Low RPM Warning System Upgrade Kit Instructions

Kit adds starter lockout feature to prevent cranking engine with clutch engaged and rotor stopped. Applicable to R22 S/N 0002 thru 2114. Replaces A569-1 low RPM warning unit & B140-1 relay with A569-5 low RPM warning unit, and A040-2 horn assembly with B320-5 horn assembly.

(Supersedes KI-69-7)

IPC Figure 95-29 illustrates low RPM warning unit installation hole locations, with A569-5 (replacement) shown.

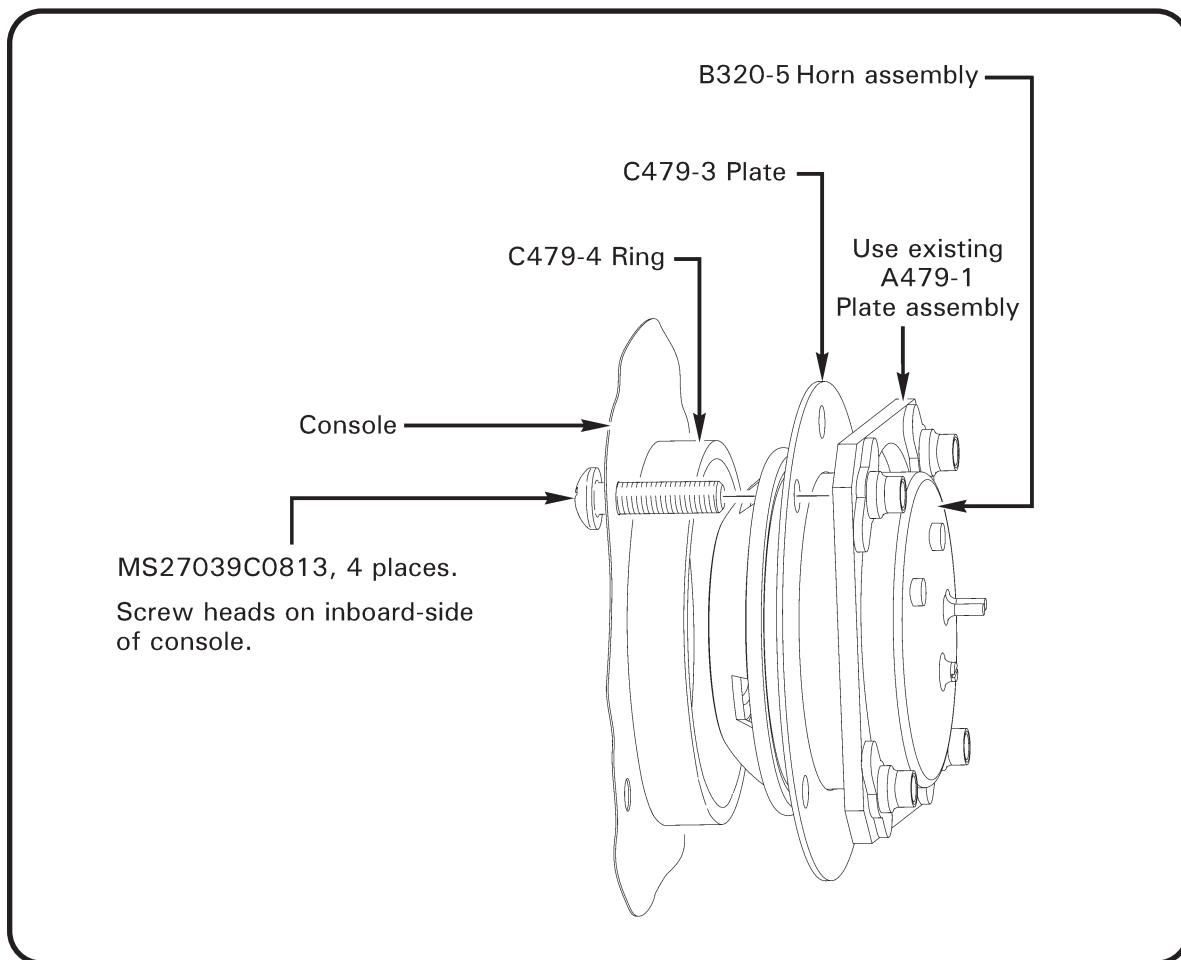
3. Position KI-69-6 template to match consoles' two existing low RPM warning unit mounting holes. Templates' extra hole must be beneath existing holes when console is in the closed position. Drill a 0.170-inch diameter hole where indicated by template.
4. Position A569-5 low RPM warning unit so adjustment screw can be seen through consoles' access hole. Secure unit using (3) MS35206-241 screws.
